COTTER CORPORATION (N.S.L.)
PARTIAL RESPONSE TO

COLORADO DIVISION OF RECLAMATION, MINING AND SAFETY
PRELIMINARY ADEQUACY REVIEW
DATED AUGUST 29, 2012
OF
Schwartzwalder Mine, Permit No. M-1977-300
Amendment 4

Submitted to DRMS
September 21, 2012

Figure 2 RO Unit Process Flow Diagram

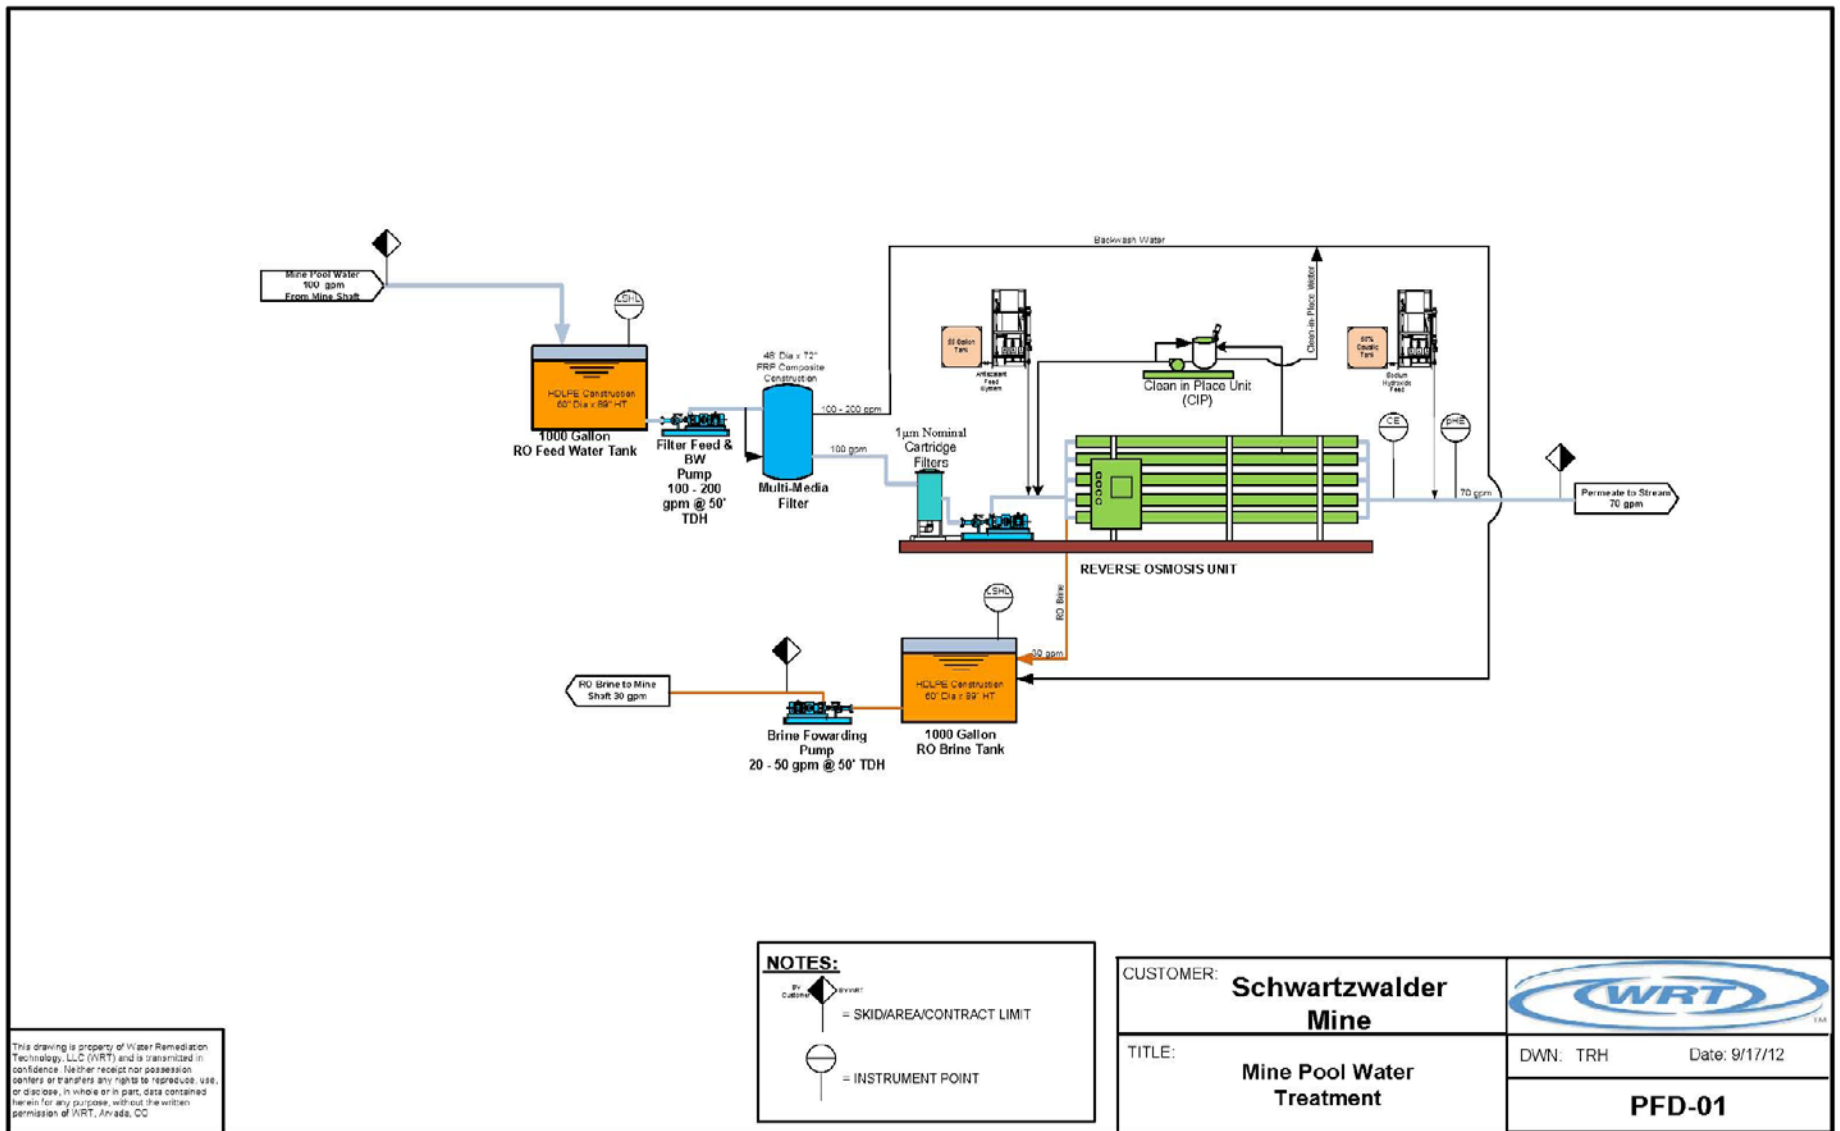
1. As an alternative to pumping down the mine pool to 500 feet below the Steve Level, DRMS will consider approving a plan to pump the mine pool down to 150 feet below the Steve Level. The Division would consider a plan for an immediate pump down of the mine pool to 150 feet and maintaining the mine pool elevation at 150 feet throughout the in-situ treatment trial phase of AM-04. An immediate pump down to 150 feet would reduce the mine pool to an elevation of approximately 63 feet below Ralston Creek in the permit area (thus preventing mine pool flow toward the creek), while also reducing the exposure of wall rock in the workings, compared to pumping down to the 500-foot level (thus minimizing uranium oxidation in the workings).

- E. The discharge of the RO unit will be in two streams; approximately 70% of the RO Feed will be available for discharge under Cotter’s current discharge permit (the “RO Effluent”) while the remaining approximately 30% of the RO Feed will be returned to the mine pool (the “RO Concentrate”). Included in this RO Concentrate will be any other waste water generated by the operation of the RO unit, including but not limited to filter backwash and membrane wash water. See Figure 2 below, the RO unit process flow diagram.

- H. The RO Concentrate will be pumped from the discharge of the RO unit, via a forwarding pump through 1 ½-inch piping, to the Steve adit and through the 3-inch diameter stainless steel pipe penetration in the Bulkhead. This 1 ½-inch pipe will be continued to the top of the Schwartzwalder Mine shaft #1 and down the shaft to a depth of at least 500 feet.

Figure 4 Tentative Mine De-Watering with In-Situ Treatment Schedule

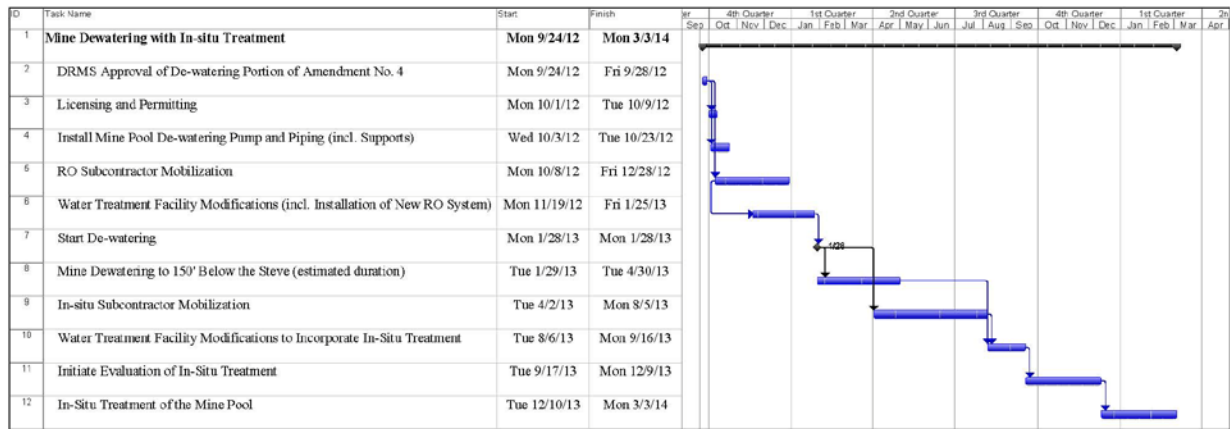
2. Please change the chronologic sequence of the tasks shown in Figure 18 of Exhibit E so that pumping down the mine pool is not delayed by a task or a portion of a task that is not absolutely essential for pumping down the mine pool. Please add a statement at the

beginning of Section E-5.3 that clearly explains Cotter will immediately initiate pumping down the mine pool, and the pumping will precede the initiation of in-situ biologic treatment of the mine pool.

Cotter intends to immediately accelerate pumping down the mine pool as detailed in the De-Watering Schedule shown in Figure 3 above. This pumping will be done before proceeding with in-situ biologic treatment of the mine pool. Figure 18 of Exhibit E will be amended to reflect this change in the chronologic sequence of task and will be similar to Figure 4 below.

Figure 1. Proposed Monitoring Well Location

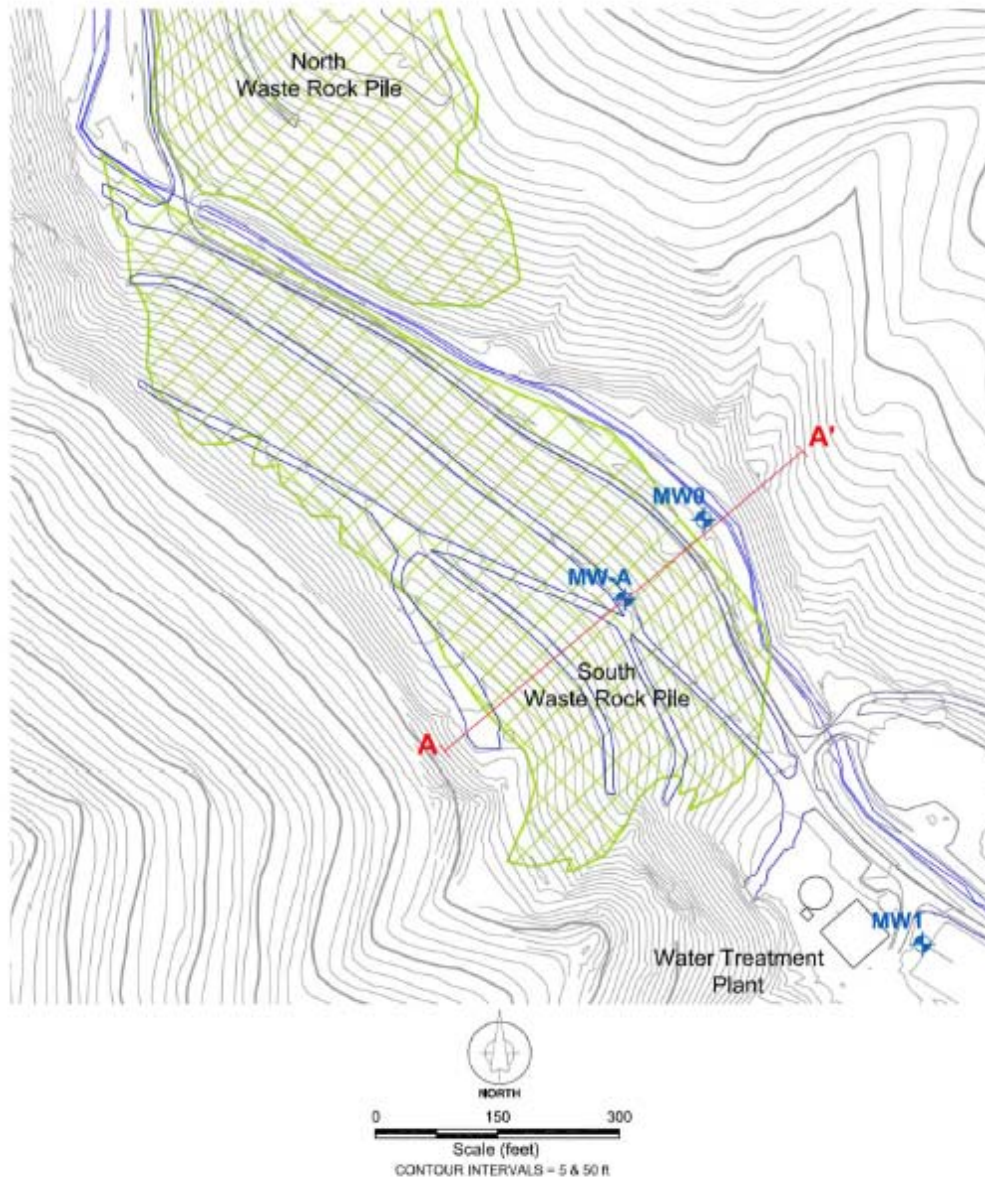
20. Please add to Exhibit E a plan for installing a monitoring well in the alluvium beneath the South Waste Rock Pile.

The proposed monitoring well location is shown in Figure 1 using the temporary well ID of "MW-A". The well will be assigned a sequential numeric ID when drilling begins. The site is located along the existing access road on the waste rock pile, approximately 170 feet from the toe of the pile, at an elevation of 6,645 ft.

Figure 1. Proposed Pan Lysimeter Locations

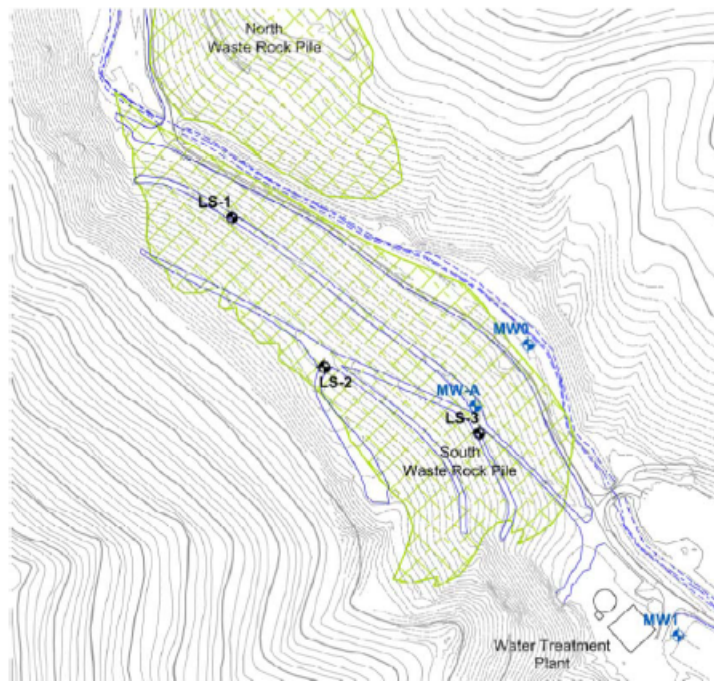
21. Please consider using pan lysimeters instead of suction lysimeters for monitoring infiltration through the South Waste Rock Pile.

The Soil Moisture® model 1960 pan lysimeters will be installed at three locations in the South Waste Rock Pile. The locations have been selected to be representative of conditions across the pile, and are shown in Figure 1.
